# UNITED STATES PATENT AND TRADEMARK OFFICE

APPLICATION NO.	FILING DATE	FIRST NAMED INVENTOR	ATTORNEY DOCKET NO.	CONFIRMATION NO.
10/525,779	09/30/2005	Peter Berenbrink	2002P14078WOUS	8492

<b>Office Action Summary</b>	<b>Application No.</b> 10/525,779	<b>Applicant(s)</b> BERENBRINK ET AL.	
	<b>Examiner</b> Carl D. Price	<b>Art Unit</b> 3749

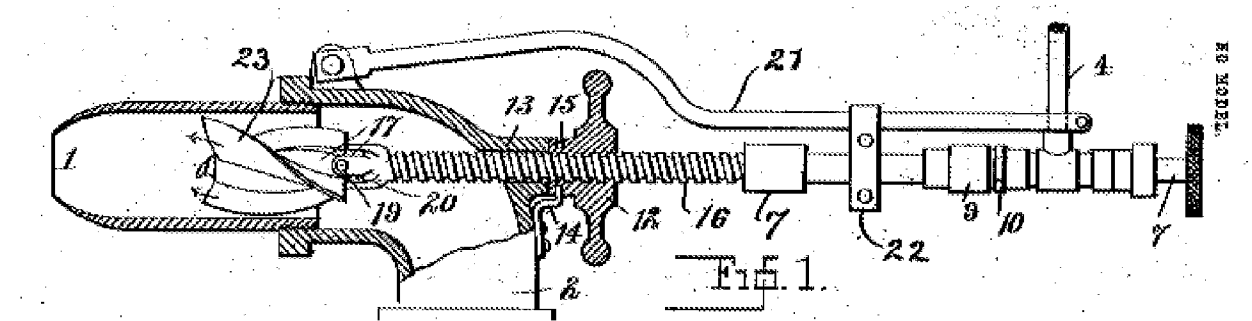
**Claims 33-35** are rejected under 35 U.S.C. 102(b) as being anticipated by **US 0746525 (Knobs)**.

**US 0746525 (Knobs)** shows and discloses a burner, comprising:

- a means for providing a flow of compressed air (2) in a flow direction;
- a means for imparting a swirl (23; spiral vanes) of the mixture about the flow direction, wherein an outflow angle of the swirled mixture varies in magnitude in a single direction across the axis perpendicular to the flow direction.

**Fig. 8.**

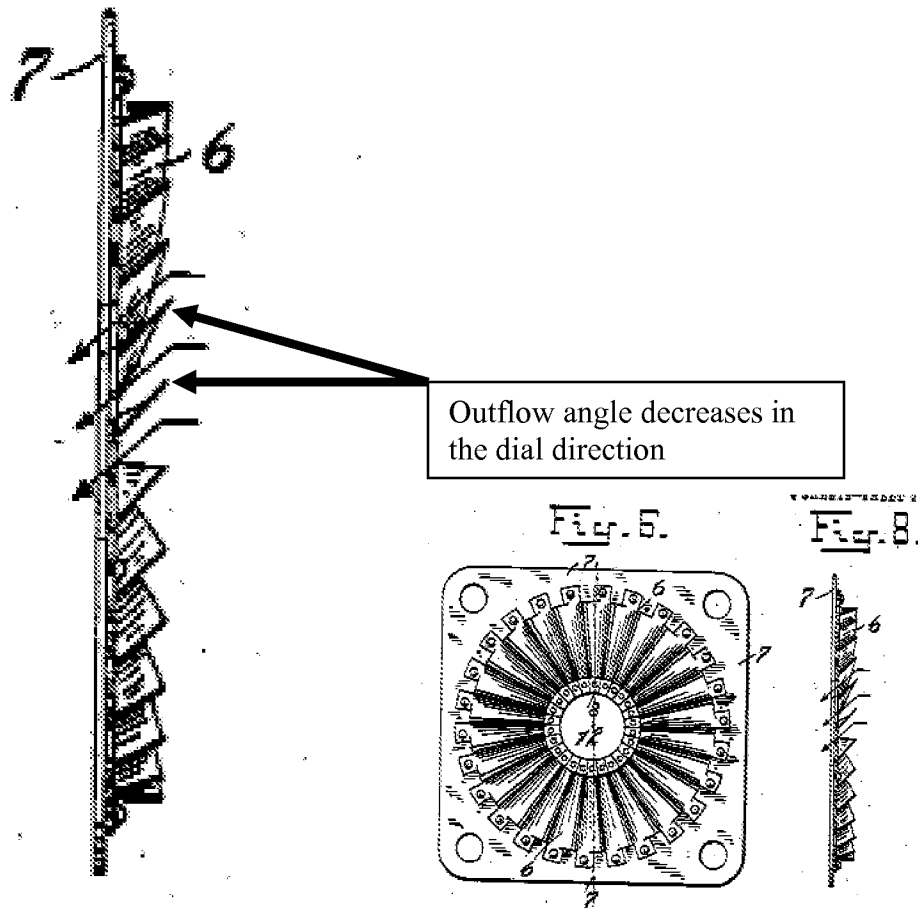
**Claims 33-39** are rejected under 35 U.S.C. 102(b) as being anticipated by **US 1086715 (Irish)**.

**US 1086715 (Irish)** shows (figure 8) and discloses a burner, comprising:

- a means for providing a flow of compressed air (13) in a flow direction;

- a bladed disk means for imparting a swirl 6; spiral vanes) of the mixture about the flow direction, wherein an outflow angle of the swirled mixture varies in magnitude in a single direction across the axis perpendicular to the flow direction.

**FIG 1**

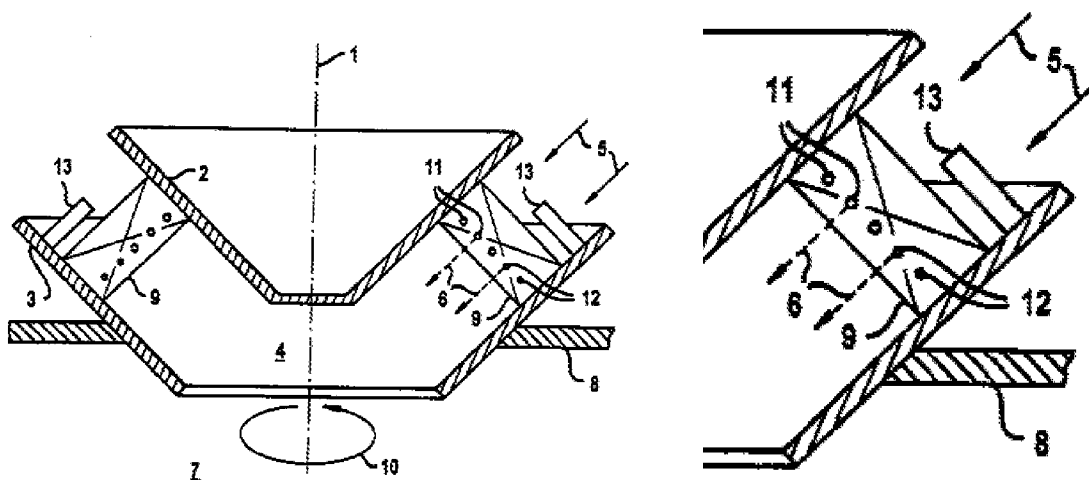
The examiner disagrees with applicant's suggestion that the claim recitation "a means for creating a mixture comprising a concentration distribution of fuel in the compressed air and/or oxygen in an axis perpendicular to the flow direction, *wherein the concentration distribution is not constant* across the axis" distinguishes the claimed invention from the prior art of Becker , since "Becker teaches selecting the size of the nozzle holes 'in such a way that a *largely homogenous distribution of the fuel in the flow* is achieved.'" On the contrary, as previously noted in the examiners action, Becker explicitly states the following:

In this regard it is noted that Becker uses a distribution of large and small nozzles positioned along an axis radially, or perpendicular, oriented with respect to the oxidant flow axis. As such, the concentration distribution is not constant across the axis, at least at points in the oxidant flow path adjacent to the nozzle locations and for at least some distance along the mixture flow. It is further noted that the recitation in Becker that the size of the nozzle holes are selected "in such a way that a *largely homogenous distribution of the fuel in the flow* is achieved". That is, since the recitation "*largely*" homogenous does not preclude a circumstance where the "*the concentration distribution is not constant*". Since Becker does not state that the distribution fuel in the flow is entirely homogeneous, or entirely uniform.

**US 6152724 (Becker)** shows and discloses.

**FIG. 1**

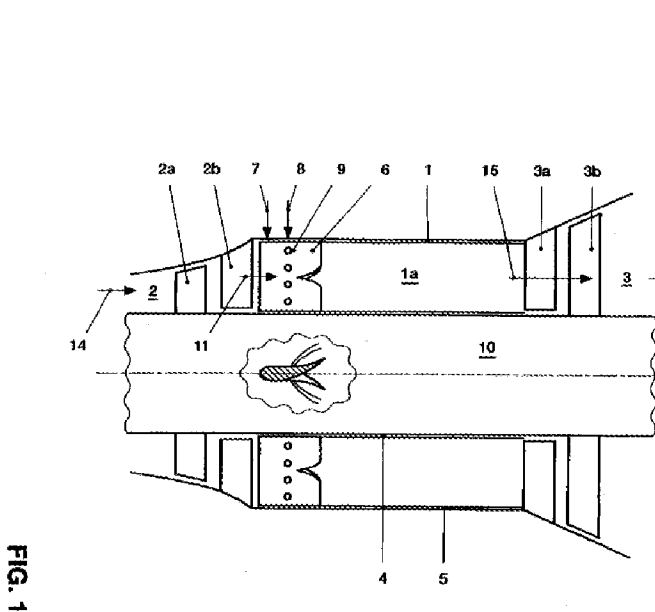
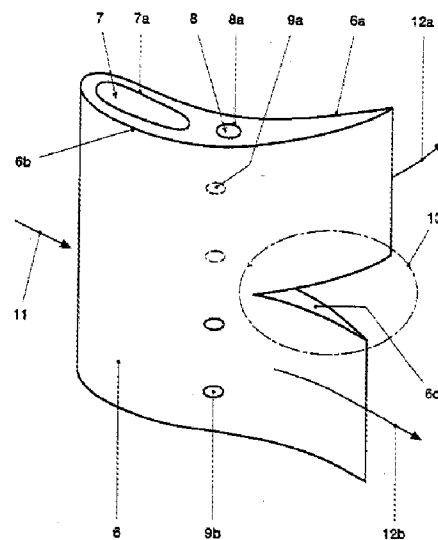
**US 5647200 (Althaus)** teaches, from the same burner field of endeavor as **US 6152724 (Becker)**, forming a fuel injector swirl blade with the outflow angle decreasing (oppositely angled) in the radial direction from the interior to the exterior, for the purpose of forming a stable back-flow zone in the combustion area.

**US 5647200 (Althaus)** shows and discloses:
